## **ADDENDUM No. 4 – Fort Sam Transportation Projects**

**PROJECT NAME: Fort Sam Transportation Projects**

**DATE: August 21, 2011**

CIMS Project No. 40-00015

7 OF 8	FINAL SUBMITTAL	PROJECT NO.: 915-12-470,etc	DATE: 8/22/2011
	DRWN. BY: RPR	DSGN. BY: JDH	CHKD. BY: RE
			SHEET NO.: 13

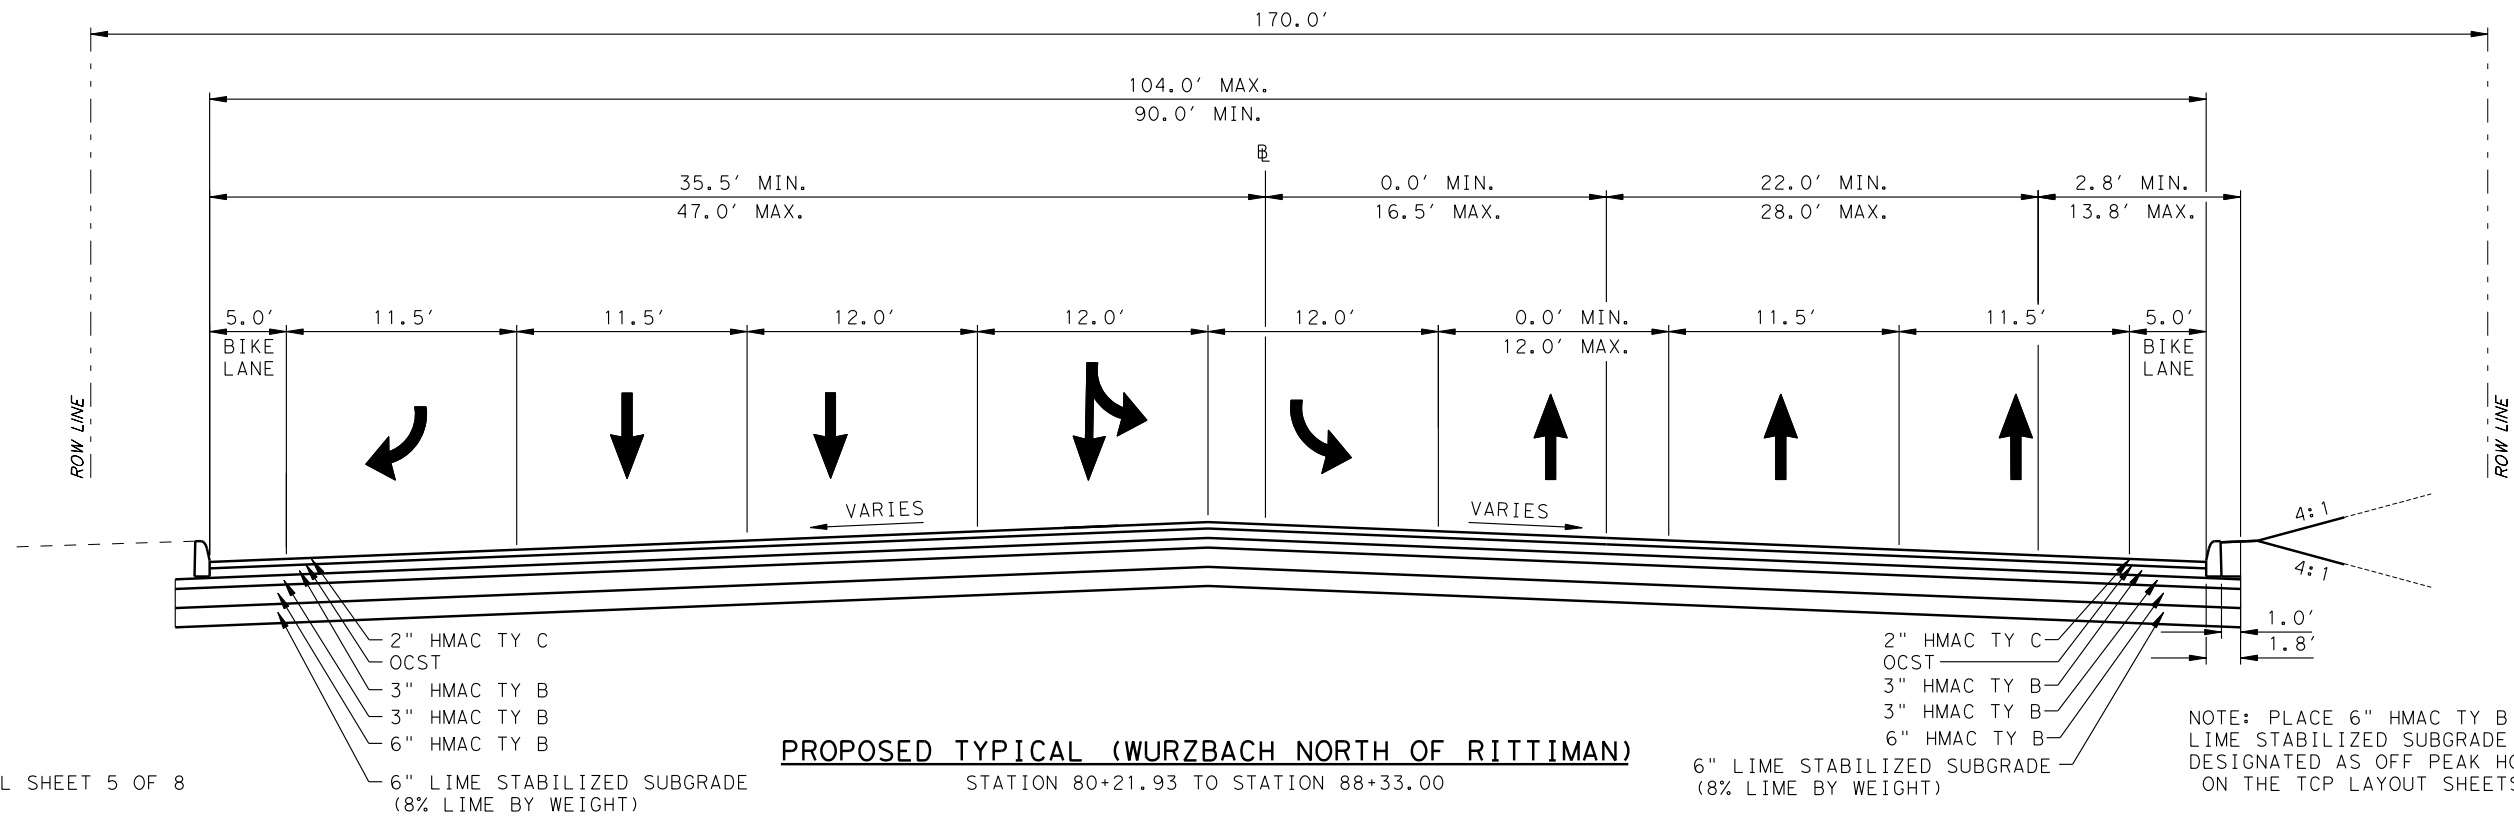
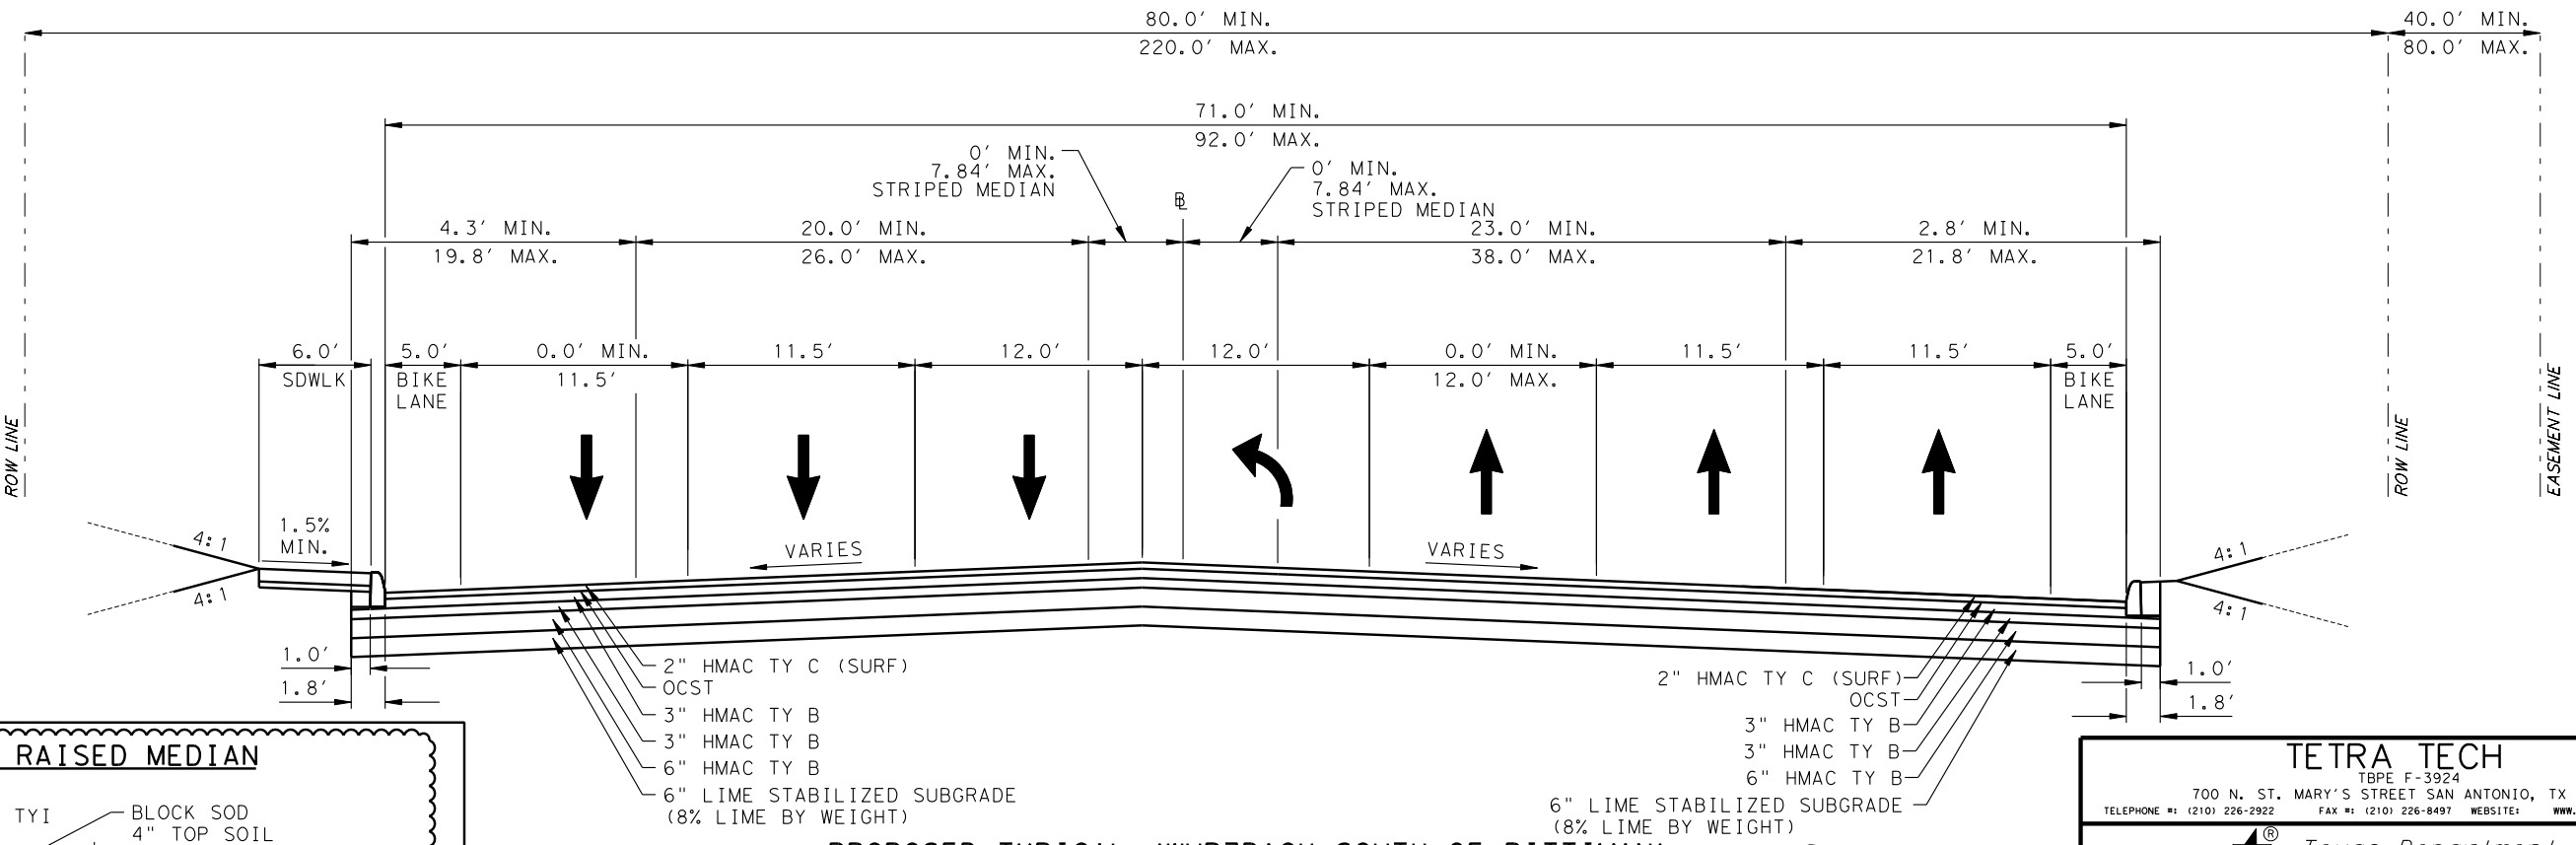
11. Should the unit of measure for pay Item 132 2001 Embankment be in Square yards?
12. Could you please provide a detail sheet for the construction of concrete medians?  
Can you please identify the type of wheel chair ramps to be installed in the medians?

12. The only proposed median will be located at the north end limits of within the project to tie in to existing median. Sheet 13 has been revised to show raised median detail.

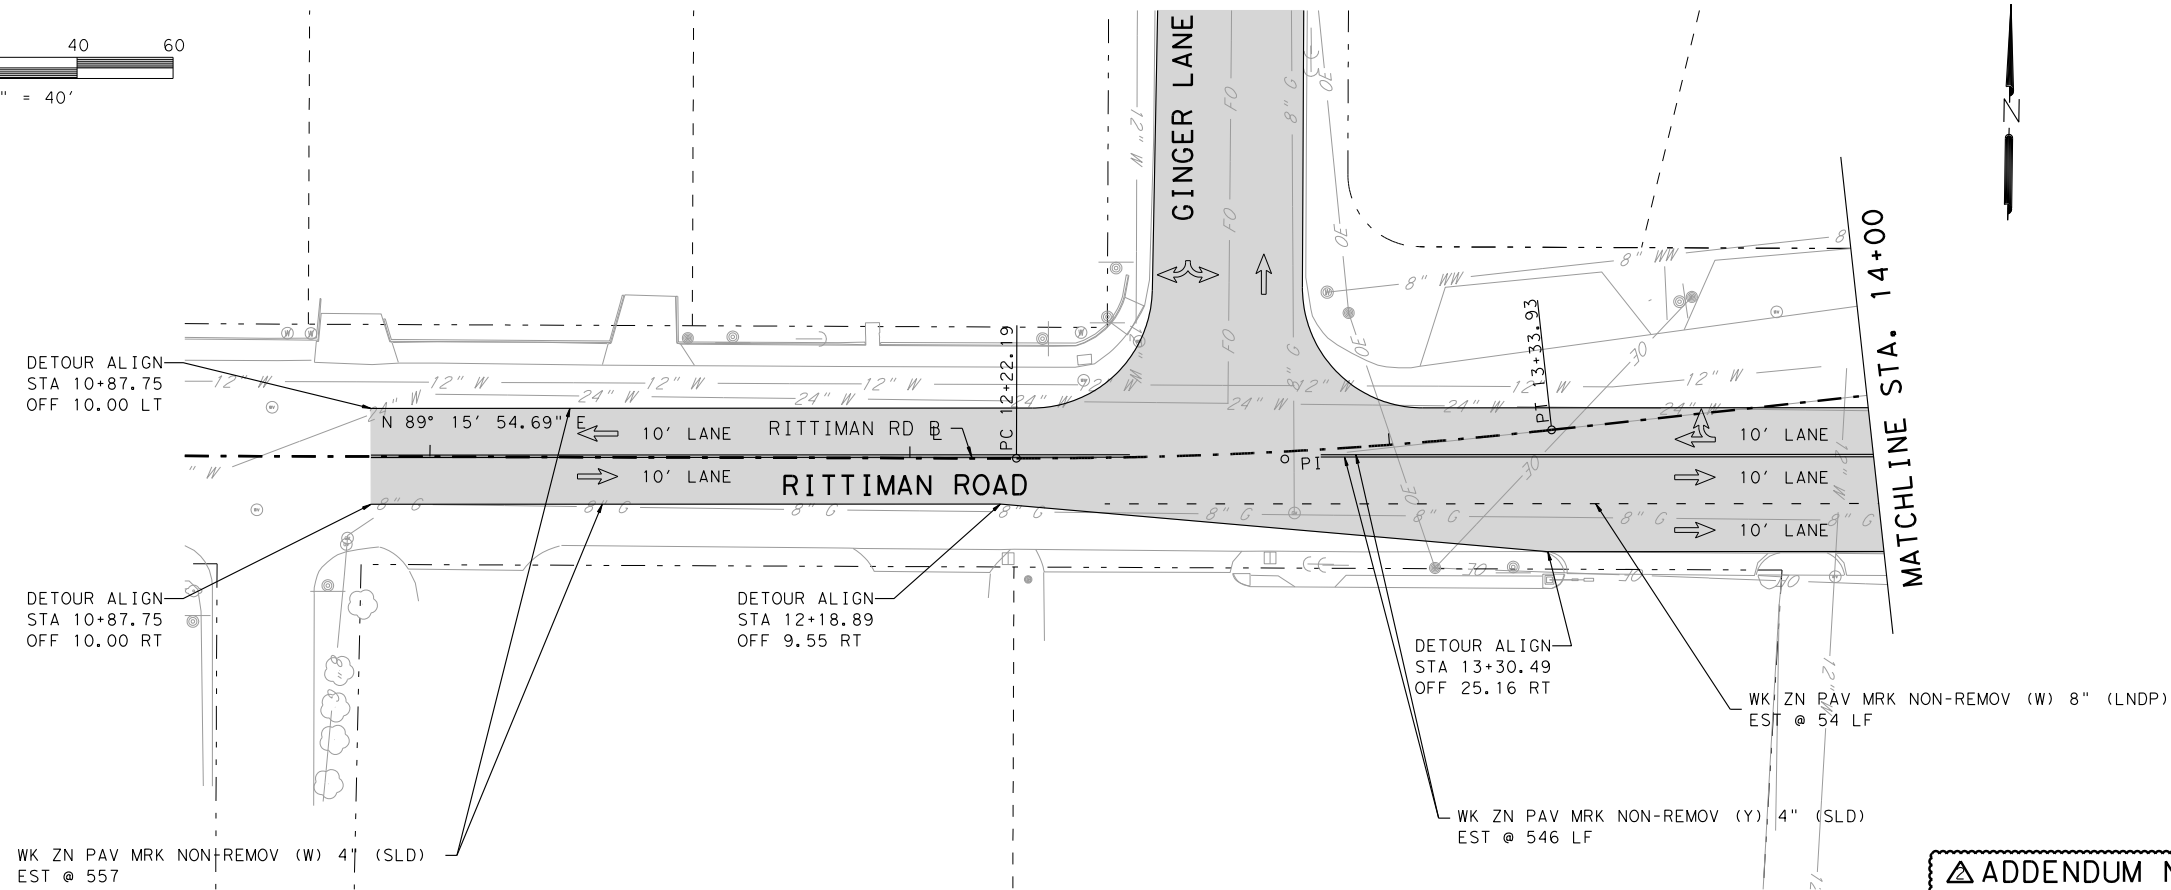
9. How many project signs will be required?
10. The narrative for the traffic control plan (sheet 37) does not agree with the TCP detail sheets. It is missing a discussion for what will be expected in various phases (e.g. Phase 1, Stage 2, etc.). Will a revised narrative be provided?

9. Two Signs, one each at the south and north end of the project on Harry Wurzbach.
10. The Narrative has been revised to coincide with TCP Phasing.
11. No, Units of Measure for Item 132 2001 Embankment is CY.

5 OF 5  
RITTIMAN RD. & HARRY WURZBACH INTERSECTION

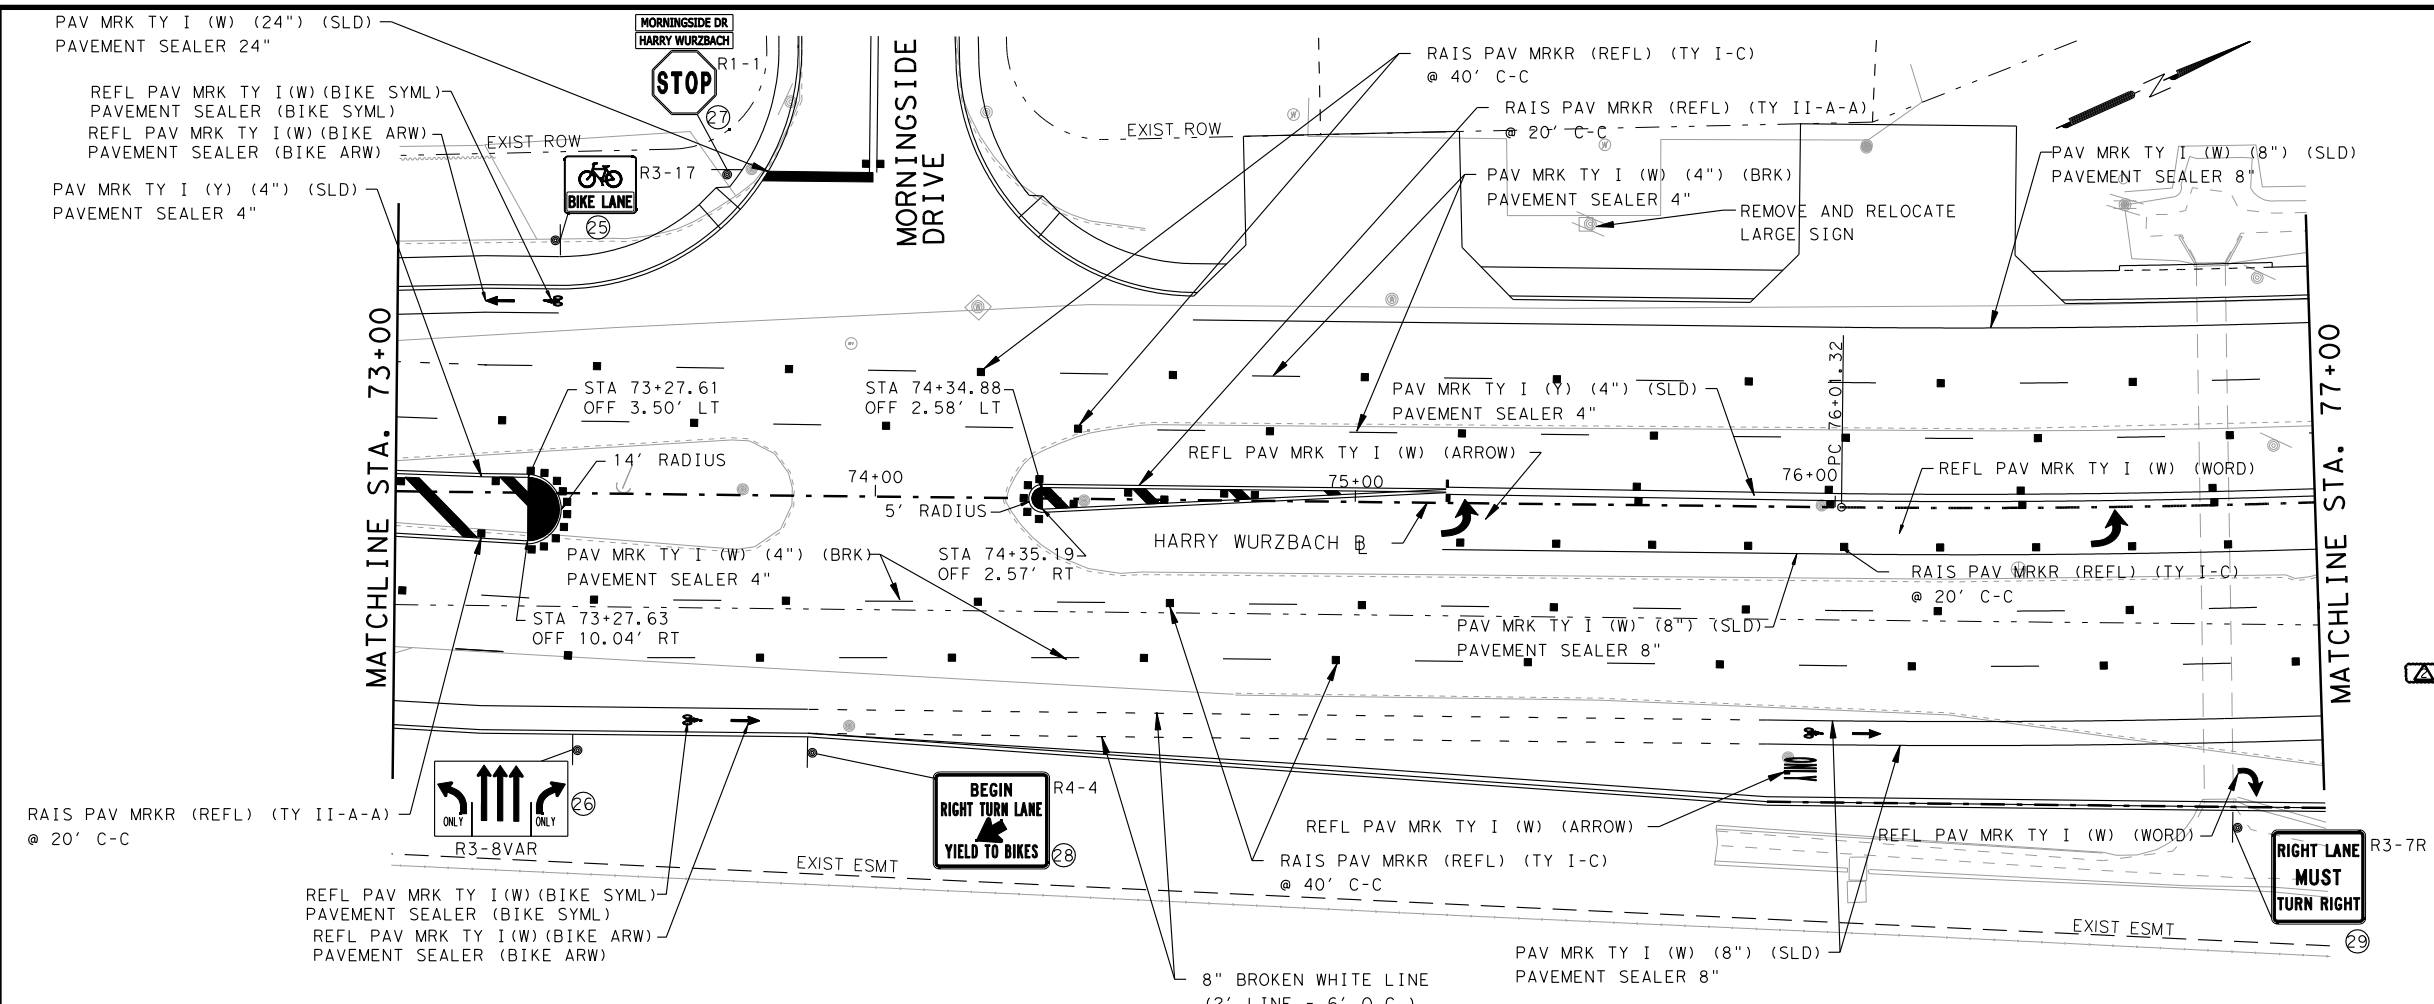
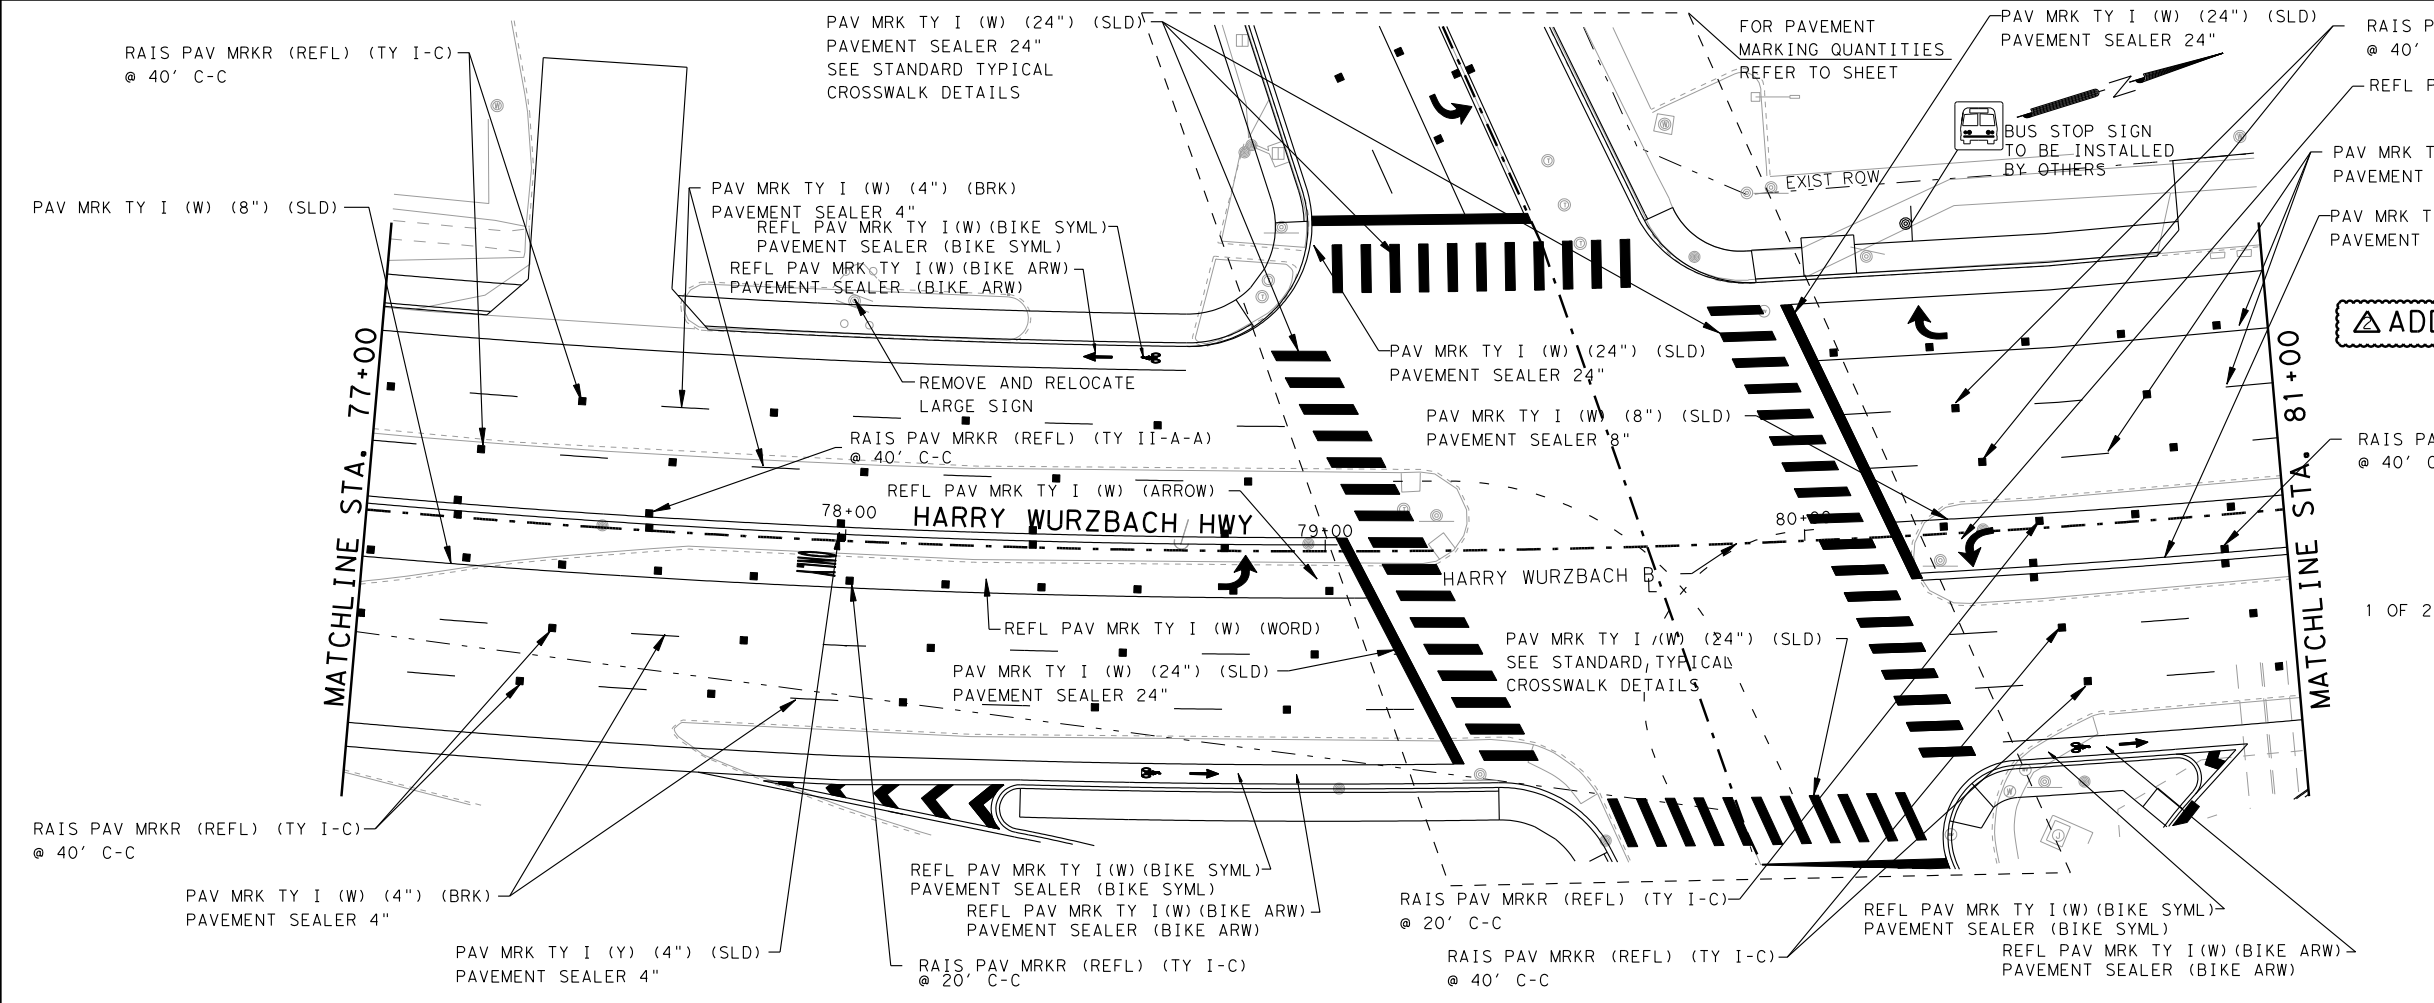
1. Will a primavera schedule be provided?
2. On pg. 215 what is the sf for the signs to be relocated?
3. Should the schedule under general notes call for a 5-day work week?

1. A Primavera schedule will not be provided. Consultant will provide a PDF copy of the contact time determination schedule.
2. The SF of the large sign will be determined by the contractor. The quantity included in Plan Sheet 215 LRSA is revised from 48 EA to 2 EA. Quantity is correct on all other sheets.

NOTE: CONTRACTOR TO PROVIDE ENGINEERING DRAWINGS AND CALCULATIONS FOR DESIGN OF LARGE SIGN AND FOUNDATION RELOCATION. COMPLETE COST INCLUDING LABOR, MATERIALS, EQUIPMENT AND PROFESSIONAL ENGINEERING DRAWINGS (SIGNED AND SEALED BY PROFESSIONAL ENGINEER) WILL BE INCLUDED IN THE COST OF THIS ITEM. REFER TO SIGNING AND PAVEMENT MARKING SHEET 215 FOR LOCATION OF EXISTING SIGNS. THE ENGINEER SHALL PROVIDE THE NEW LOCATION OF THE SIGN.
